Re: St. Lucie Plant Unit 2
Docket No. 50-389
Renewed Facility Operating License No. NPF-16

Response to NRC Request for Additional Information (RAI) Regarding Extended
Power Uprate License Amendment Request

**Response to NRC Nuclear Performance and Code Branch
Request for Additional Information**

SNPB-16

Figure-47
Large Break LOCA ECCS Performance for Limiting Seismic Loads Analysis
0.4DEG/PD Break
Peak Cladding Temperature

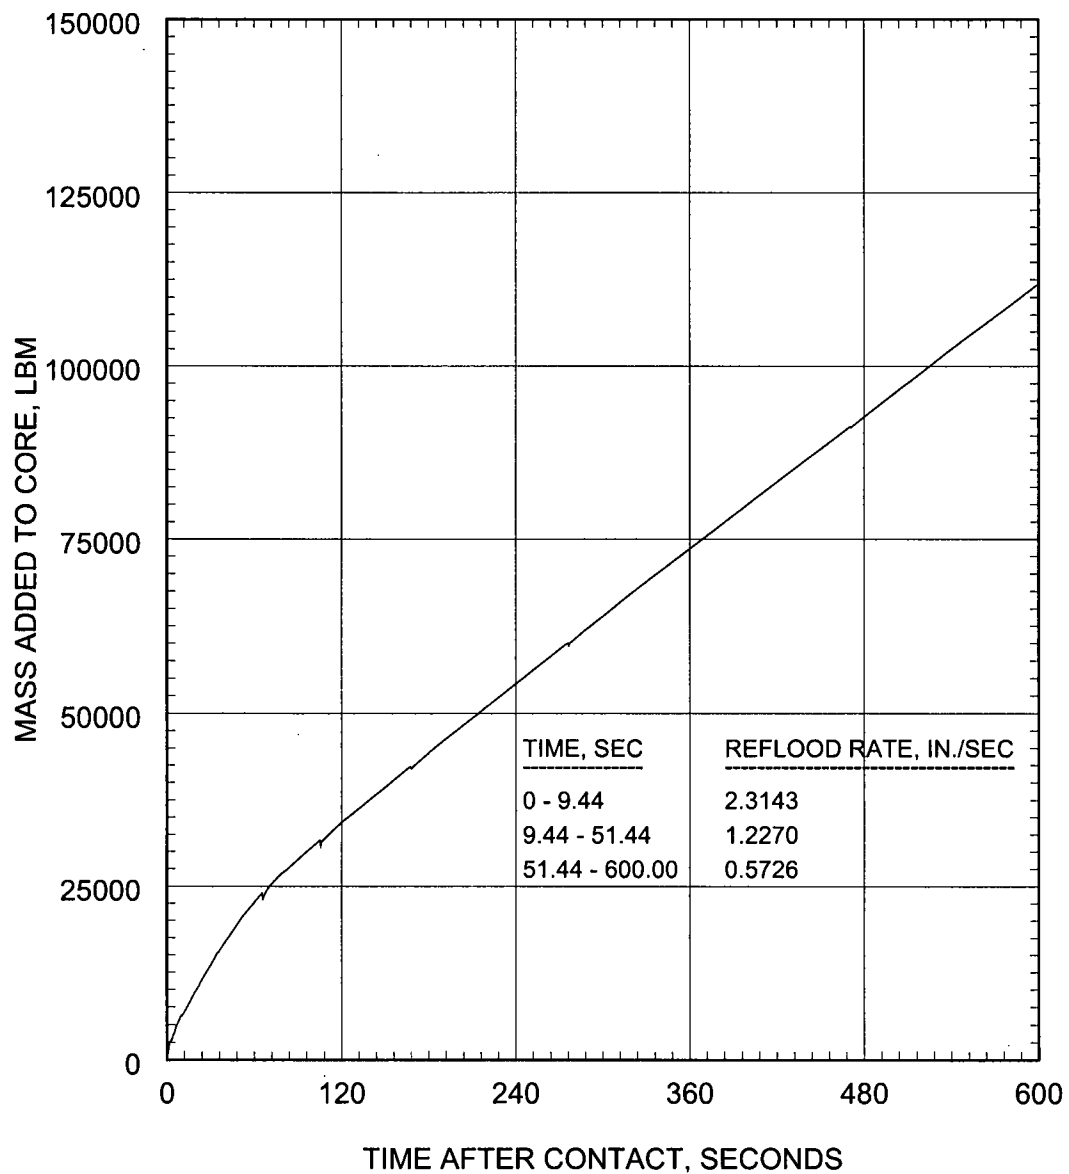
Please provide the results of the seismic LOCA loads analysis for the limiting break. Identify the maximum hot channel deformation/flow area reduction, the maximum hot bundle flow area reduction, the peak linear heat rate for the hottest rod in the assembly undergoing maximum deformation. Also, provide the linear heat rate for the bundle containing the rod with the max deformation. The analysis should provide the plots typical of the limiting large break LOCA analysis given in a chapter 15 analysis.

The variables listed in Table 2 are plotted as functions of time in Figures 1 through 9 for the 1.0 DEG/PD break, in Figures 10 through 18 for the 0.8 DEG/PD break, and in Figures 39 through 47 for the 0.4 DEG/PD break.
